GENERAL NOTES (FOR ALL P&ID EDITS):

- A. DRAWING NUMBERS CHANGED
- B. CLOUDS DENOTE ADDITIONS/ MODIFICATIONS.
- C. NOTES USED FOR REMOVALS + ASSUMPTIONS.
- D. MAIN FLOWS, VALVE TYPES AND SIZES PRIORITISED.
- E. LINE NUMBERS STILL IN PROGRESS.
- F. INSTRUMENTS/ALARMS BASED ON MAINTENANCE LIST.
- G. HAND SWITCHES & FAULT ALARMS FOR ALL MOTORS.

ASPECT										TENNANT MINING					PROJECT: TENNANT MINING PTY LTD NOBLES NOB GOLD MINE				
THIS DRAWING IS THE PROPERTY OF ASPECT ENGINEERING SOLUTIONS PTY LTD AND IS PRIVATE, CONFIDENTIAL AND IS SUPPLIED ON THE EXPRESS UNDERSTANDING THAT IT IS NOT TO BE USED FOR ANY PURPOSE OR COMMUNICATED TO ANY OTHER PERSON WITHOUT THE WRITTEN PERMISSION OF THE PROPRIETORS.										TITLE: REAGENTS PIPING AND INSTRUMENTATION DIAGRAM					SHEET A1 SCALE NTS DRG No. NNGM-100-PI-005 REVISION 0				
REV										DATE					DESCRIPTION				
DRAW										CHECK					DESIGN				
TECH APP										PROJ APP					REFERENCES				
DRG No.

PROJECT: TENNANT MINING PTY LTD NOBLES NOB GOLD MINE			
TITLE: PROCESS WATER AND AIR SERVICES PIPING AND INSTRUMENTATION DIAGRAM			
SHEET A1	SCALE NTS	DRG No. NNGM-100-PI-012	REVISION 0

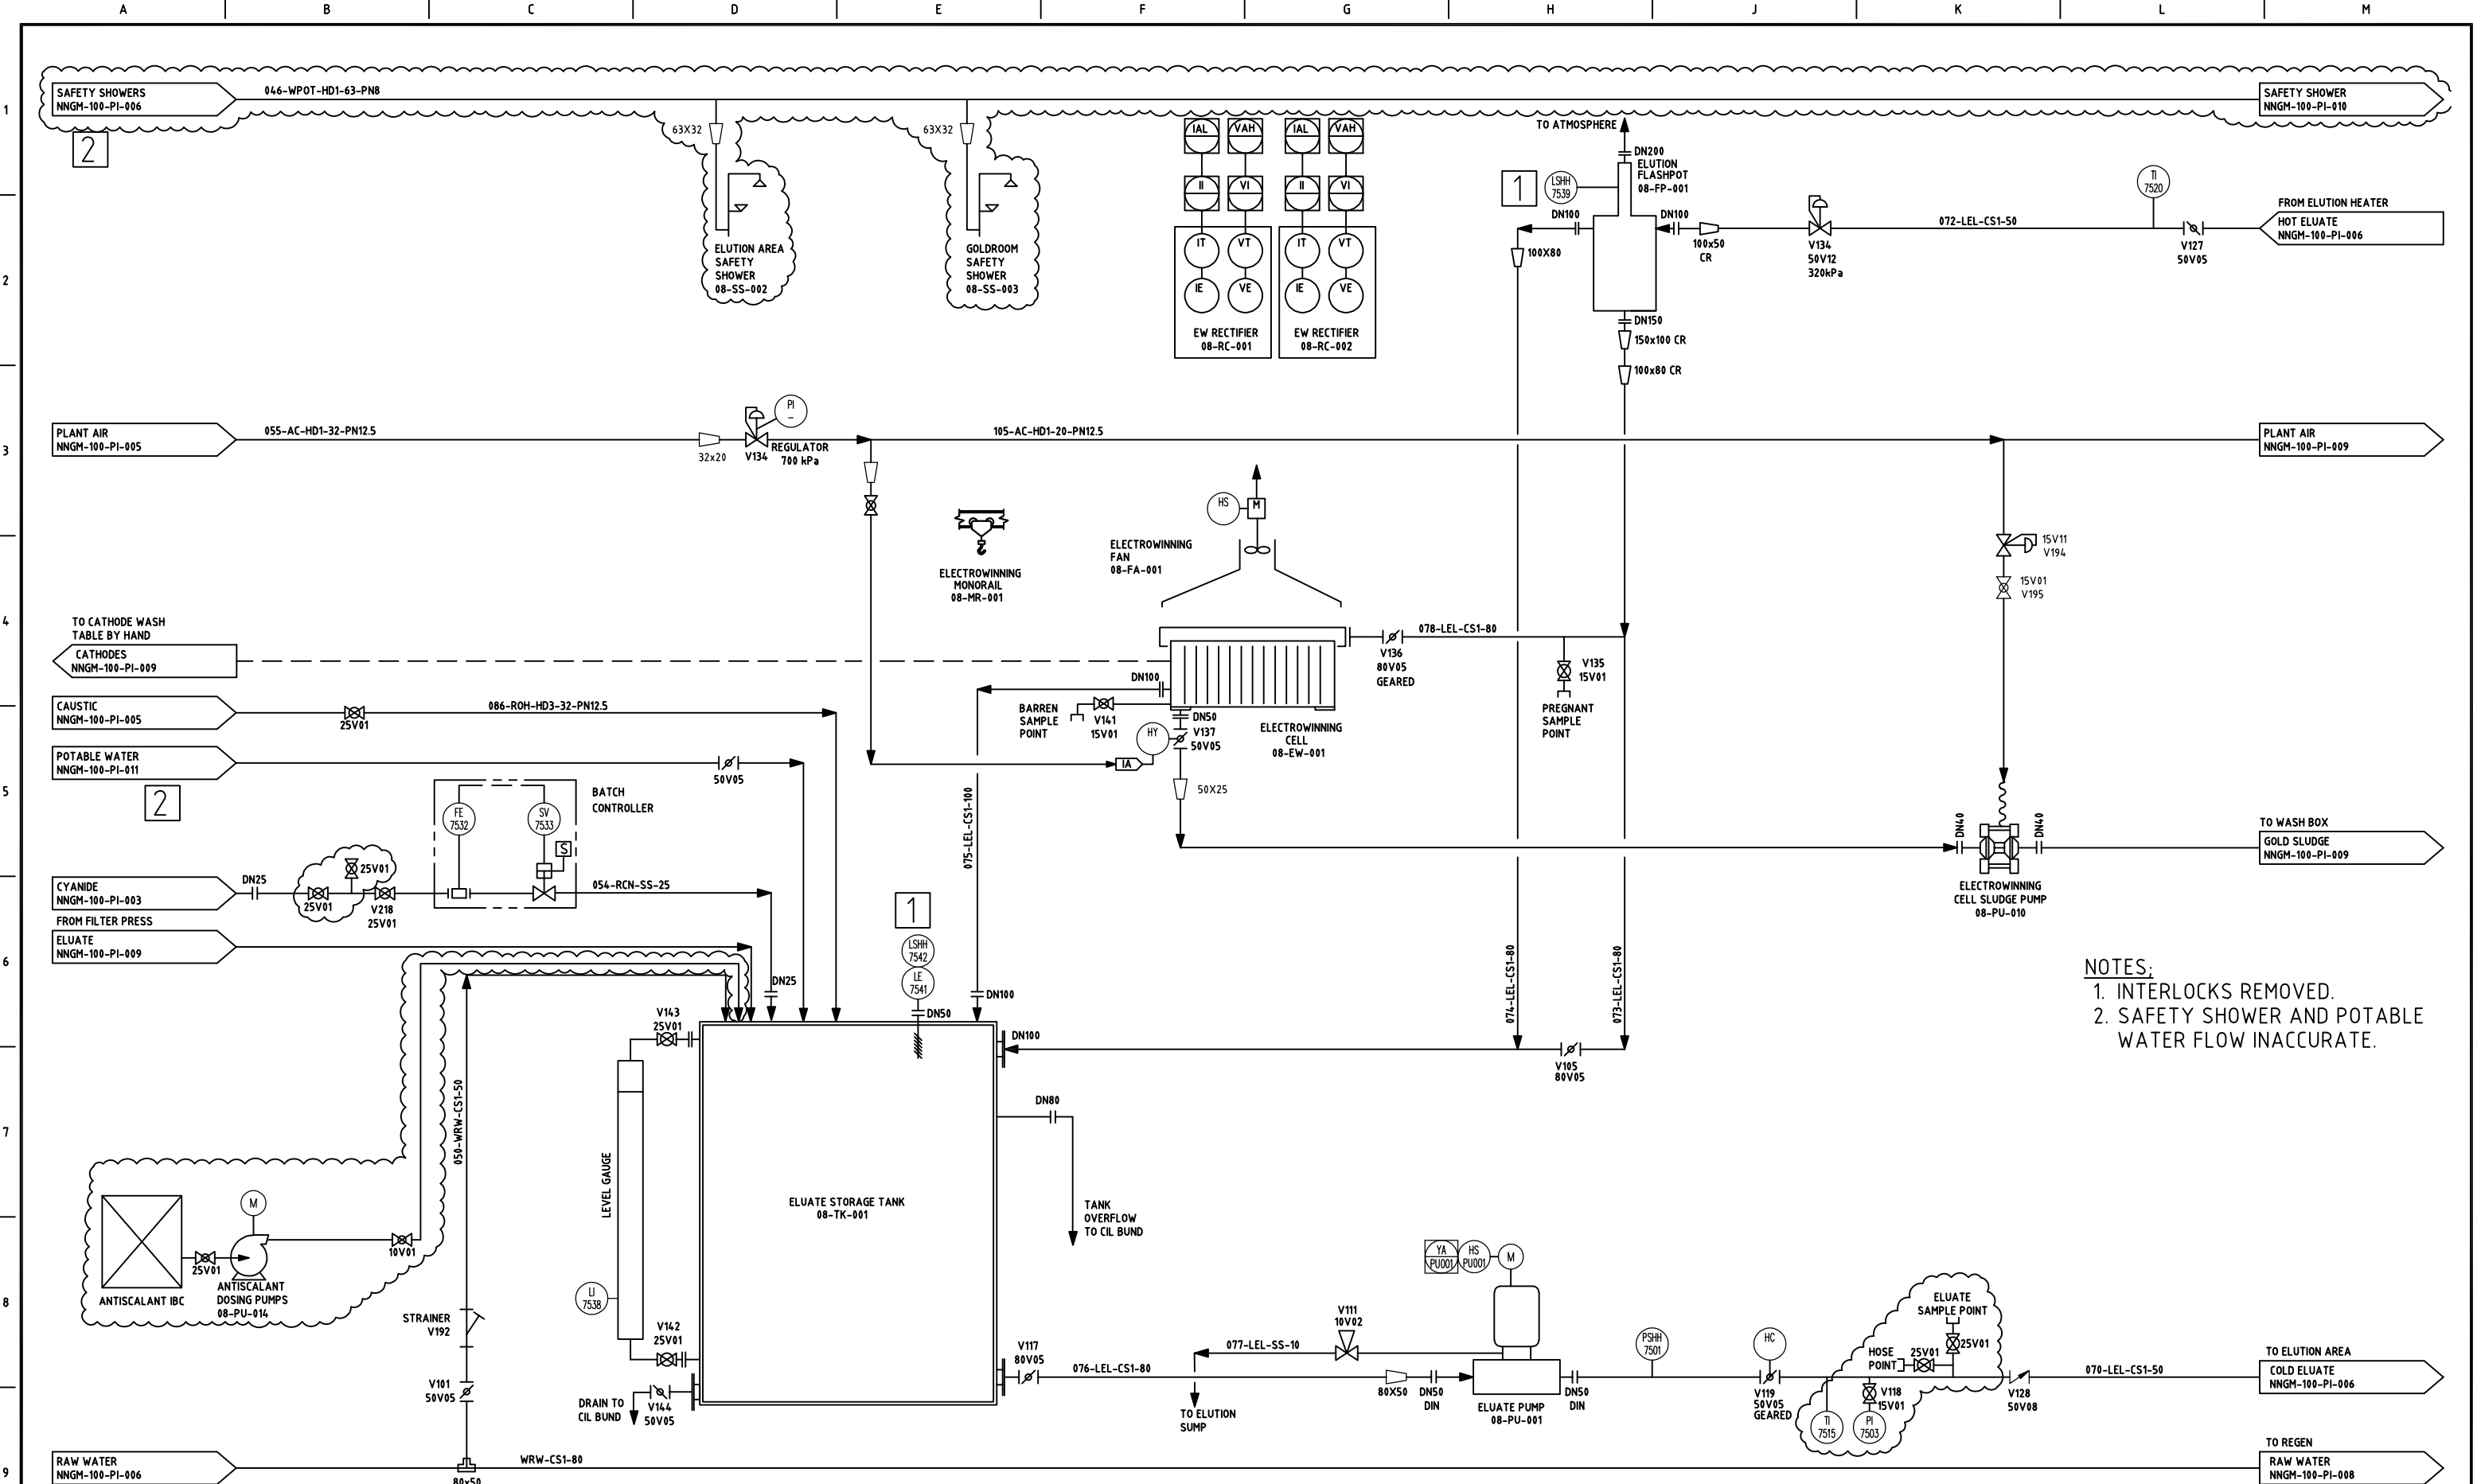
- NOTES:
- 1. INTERLOCKS REMOVED.
 - 2. SAFETY SHOWER AND POTABLE WATER FLOW INACCURATE.

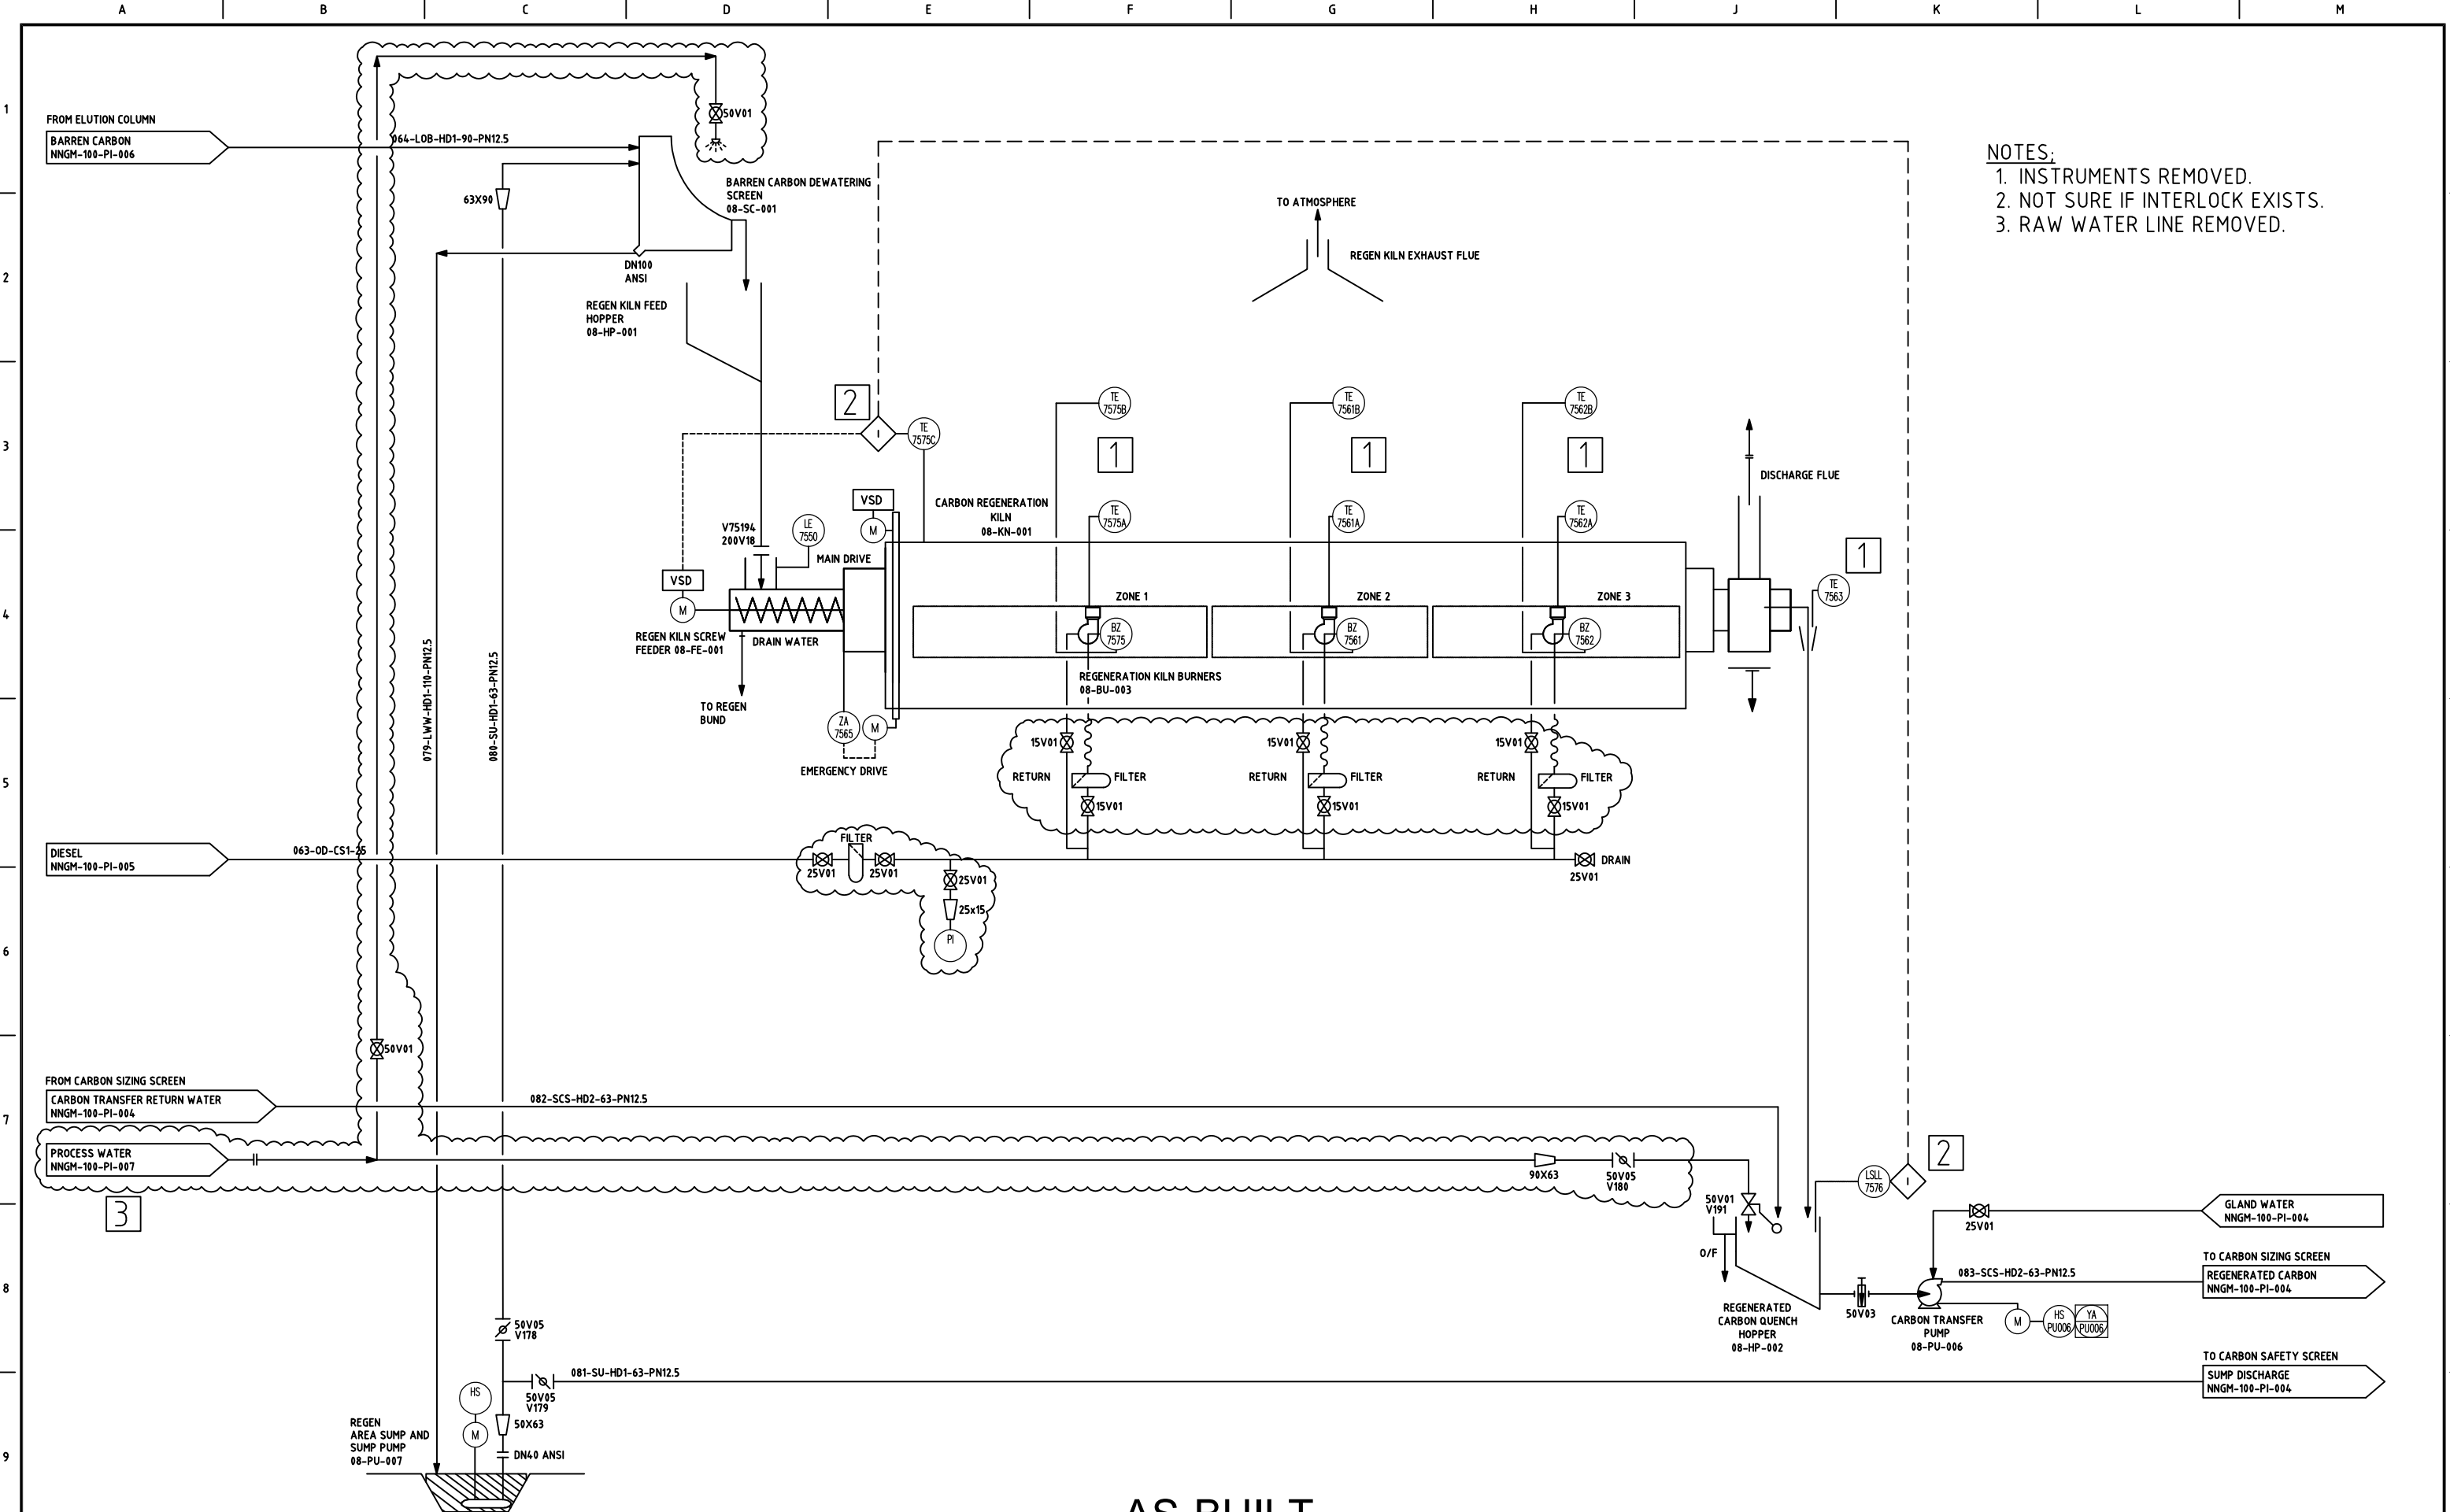
- NOTES:
- 1. INSTRUMENTS REMOVED.
 - 2. NOT SURE IF INTERLOCK EXISTS.
 - 3. RAW WATER LINE REMOVED.
